Transmitter Functional Test (TFT) Updated Proposal

P802.3dj SMF Task Force Interim Meeting

Comments: (SC 180.9.9) 116, 74, 9, 75, 117, 125, 76, 10, 2, 11, 77 / (SC 181.9.9) 12, 97, 119, 118 /
(SC 182.9.9) 129, 13, 120, 121 / (SC 183.9.9) 130, 14, 122, 123 / (SC 18n.9.15) 15, 16, 17, 18

Figure 180–4—Receiver sensitivity (OMA_{outer}), each lane (max)

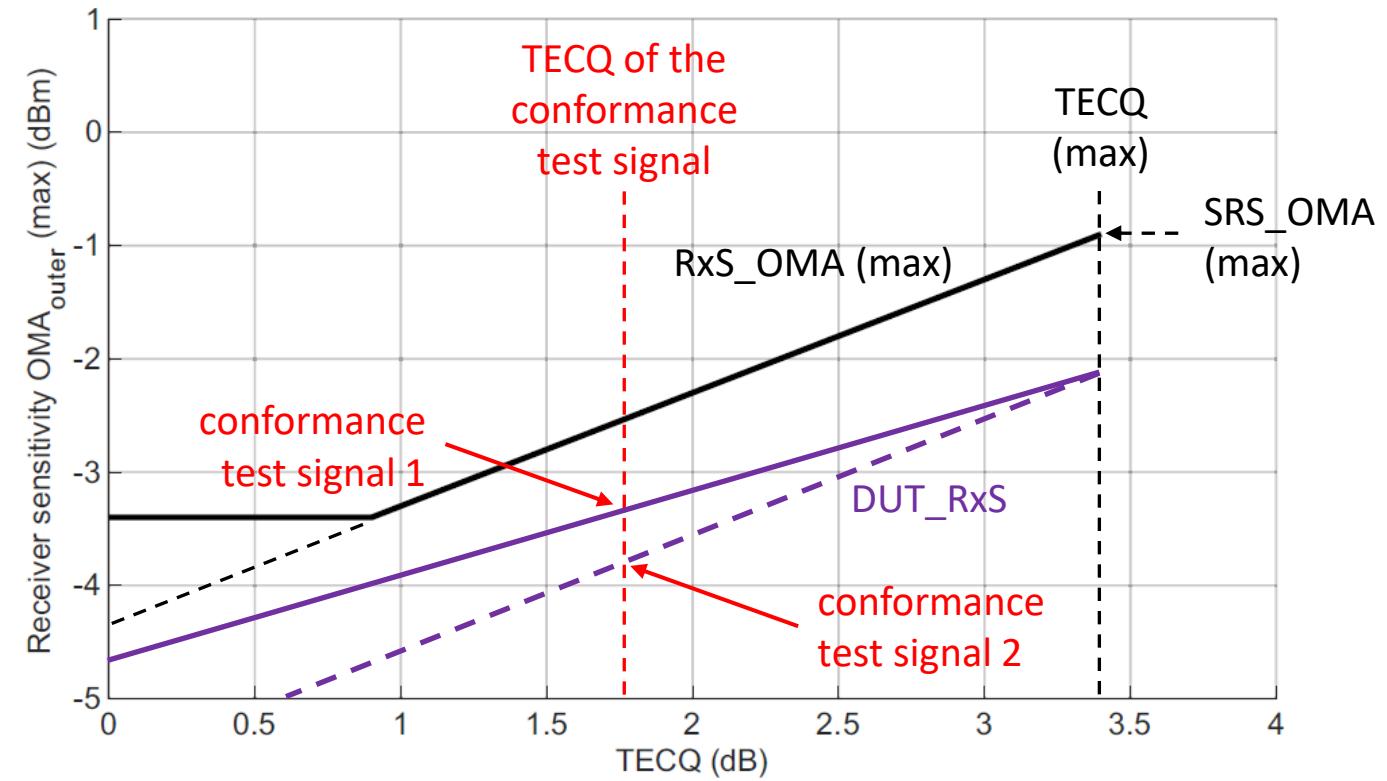
Incomplete RxS Conformance Test Signal Spec in 180.9.15

The receiver sensitivity (OMA_{outer}) of each lane shall be within the limits given in Table 180–8 if measured using a test pattern for receiver sensitivity in Table 180–14. The conformance test signal at TP3 meets the requirements for a transmitter followed by an attenuator.

The **TECQ of the conformance test signal** is measured according to 180.9.6, except that the test fiber is not used. The measured value of TECQ is then used to calculate the limit for receiver sensitivity (OMA_{outer}) as specified in Table 180–8.

The receiver sensitivity (OMA_{outer}) of each lane shall be within the limits given in Table 180–8 if measured using a test pattern for receiver sensitivity in Table 180–14. ~~The conformance test signal at TP3 meets the requirements for a transmitter followed by an attenuator.~~

The conformance test signals at TP3 are at least three separate signals, as specified in 180.9.16: 1) with no changes, 2) with the Gaussian noise generator and sinusoidal interferer turned off, and sinusoidal jitter on, and 3) with the Gaussian noise generator, sinusoidal interferer and sinusoidal jitter turned off.

Remedy to comments: 15, 16, 17, 18, 117, 119, 121, 123

Figure 180-4—Receiver sensitivity (OMA_{outer} , each lane (max))

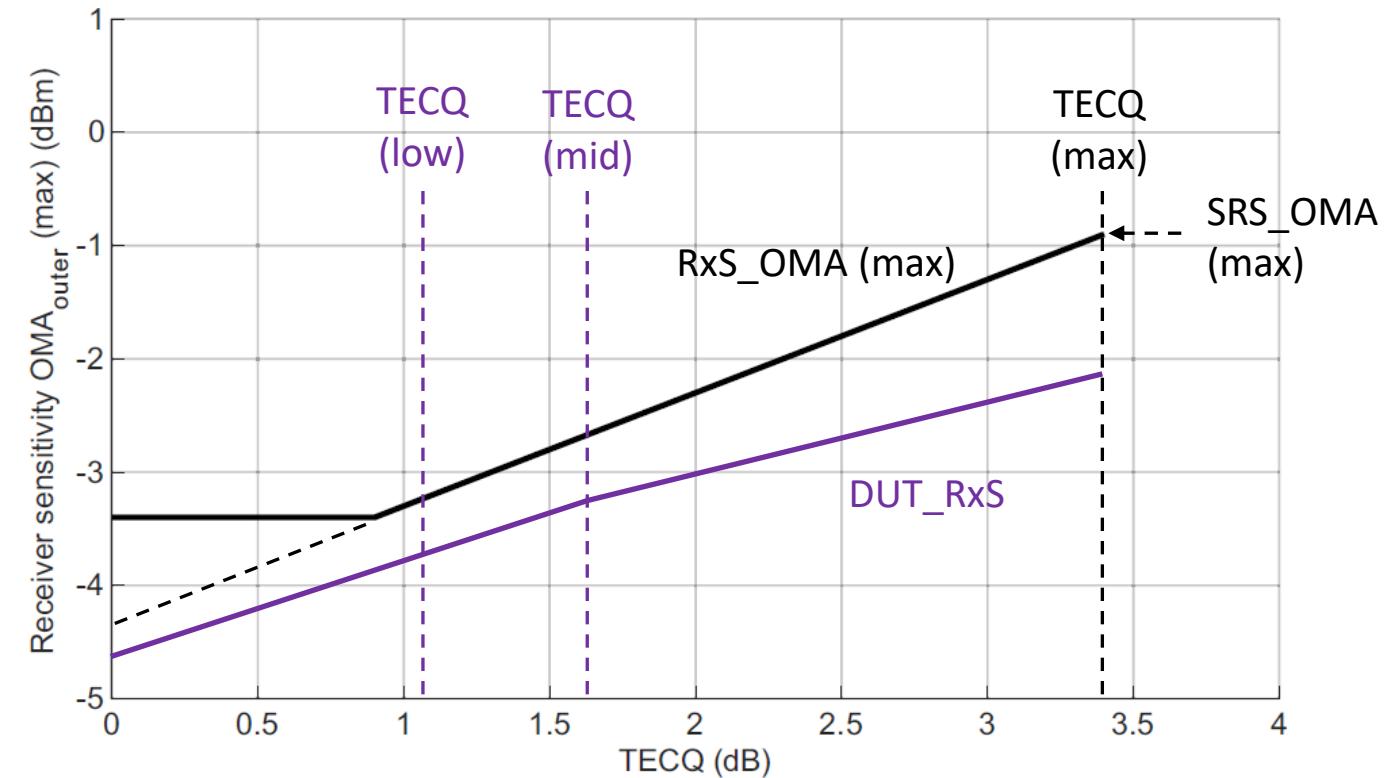
Ex. Proposed RxS Conformance Test Signal at TP3

Proposed RxS Conformance Test Signal at TP3 specified in 180.9.16 except			
TECQ	Gaussian noise generator	sinusoidal interferer	sinusoidal jitter
max	on	on	on
mid	off	off	on
low	off	off	off
